Technical Service Information

FORD E4OD SLIPPING OR NO REVERSE AND OR NO ENGINE BRAKING IN MANUAL "2" or "1", 1996-1998

Figure 1

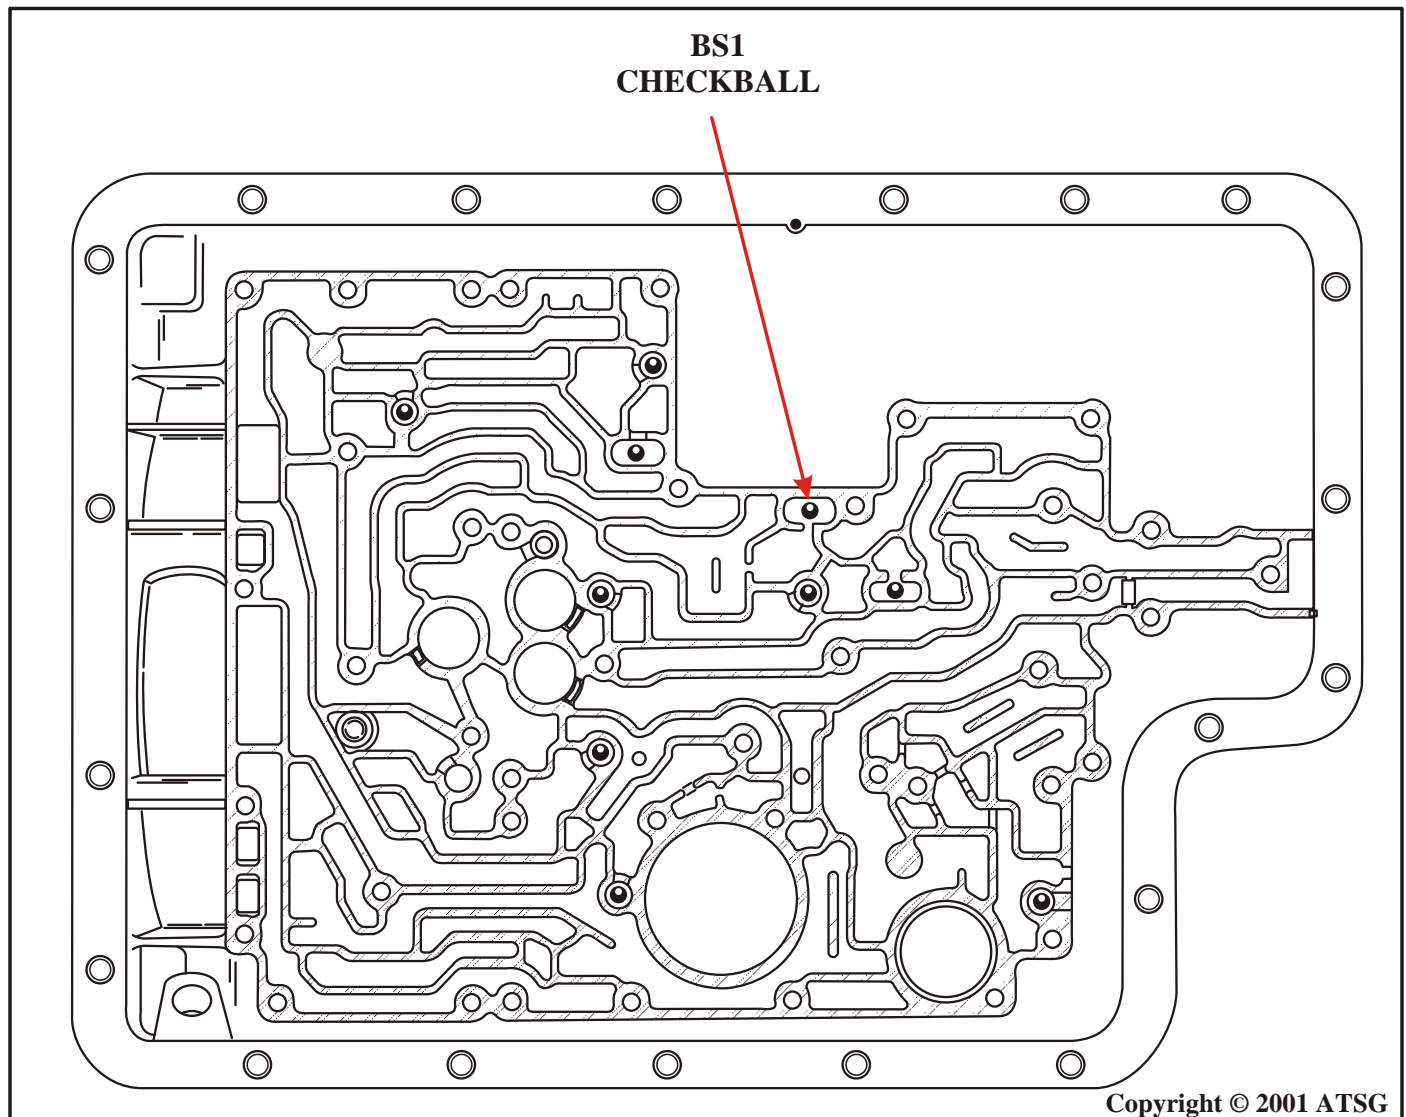
COMPLAINT: Before and/or after overhaul, 1996-1998 Ford Motor Company vehicles equipped with the E4OD transmission may exhibit a slipping or no reverse, and or no engine braking condition with the selector in the Manual 2 or Manual 1 position.

CAUSE: The cause may be a missing or misplaced BS1 checkball. When this checkball is missing, oil pressure in the Reverse or Manual 2 or Manual 1 position will be exhausted at the Manual Valve.

CORRECTION: To correct this condition, install the BS1 checkball at the location as shown in Figure 1.
